# Access Compliance Report

## Public Rights-of-Way

Intersection ID: 53044	Main Street: MELODY_WOODS_CT	Cross Street: WILLOW_OAK_RD	Location: NE
ADA ID: 36673507F5D7	Ramp Type: Perp	Initial Pass/Fail: Fail	Overall Compliance: No
		Severity Score: 1.25

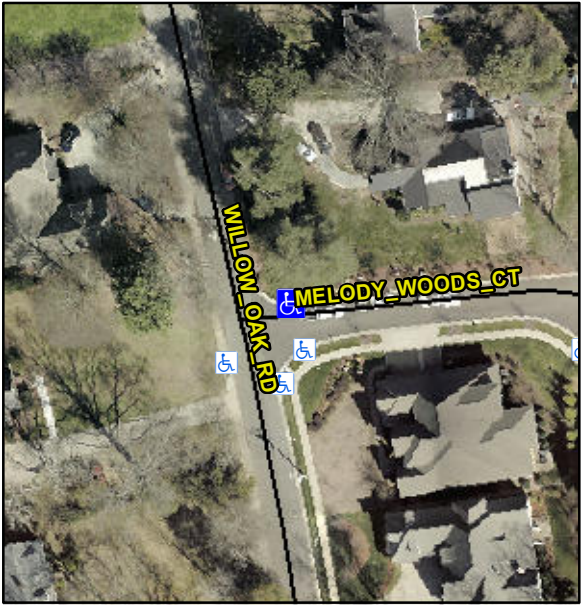
Codes/Mitigation Info/Possible Solution		Field Measurements/Component Compliance					
	Possible Solutions:	<b>Compliance</b>	<b>Description</b>	<b>Data</b>	<b>Compliance</b>	<b>Description</b>	<b>Data</b>
	<b>Remove &amp; Replace Entire Ramp.</b>	N/A	Ramp Length (in)	110.0	Yes	Ramp Slope (%)	5.9
		Yes	Ramp Width (in)	48.0	No	Ramp XSlope (%)	3.9
		N/A	Flare Type LT	N/A	N/A	Flare Type RT	N/A
		N/A	Flare Slope LT (%)	N/A	N/A	Flare Slope RT (%)	N/A
		N/A	Flare Traversable LT?	N/A	N/A	Flare Traversable RT?	N/A
		N/A	Landing Length (in)	N/A	N/A	DWS Provided?	N/A
		N/A	Landing Width (in)	N/A	N/A	DWS Contrast?	N/A
		N/A	Landing Slope (%)	N/A	N/A	DWS Length (in)	N/A
		N/A	Landing X Slope (%)	N/A	N/A	DWS Full Width?	N/A
		N/A	Landing Curb? (Y/N)	N/A	N/A	DWS Offset (in)	N/A
		N/A	Shared Landing?	N/A			
		N/A	Gutter Ponding?	N/A	N/A	Gutter Slope (%)	N/A
		N/A	Gutter Lip Ht (in)	2.0	N/A	Gutter X Slope (%)	N/A
		N/A	Painted X Walk1?	No	N/A	Painted X Walk2?	N/A

X Walk 1 Direction	To S		X Walk 2 Direction	N/A
		N/A	X Walk 1 Width (in)	N/A	N/A	X Walk 2 Width (in)	N/A
			X Walk 1 Slope (%)	0.3		X Walk 2 Slope (%)	N/A
			X Walk 1 X Slope (%)	3.3		X Walk 2 X Slope (%)	N/A
		N/A	Ramp inside XWalk1?	N/A	N/A	Ramp inside XWalk2?	N/A
<p>Surveyor Notes:</p> <p>N/A</p> <p>PROW/ADA:</p> <p>Not Found, R304.5.3</p>			Road Slope (%)	N/A	N/A	Clear Space?	N/A
			Road X Slope (%)	N/A	N/A	Clear Space to XWalk (in)	N/A
		N/A	Any Obstructions?	N/A	N/A	Storm Grate/Utility Hazard?	N/A
			Obstruction Type			Storm Grate/Utility Type	
					N/A		N/A
					Yes	Surface Condition? (G/P)	Good
Total Cost:		\$	1850.00
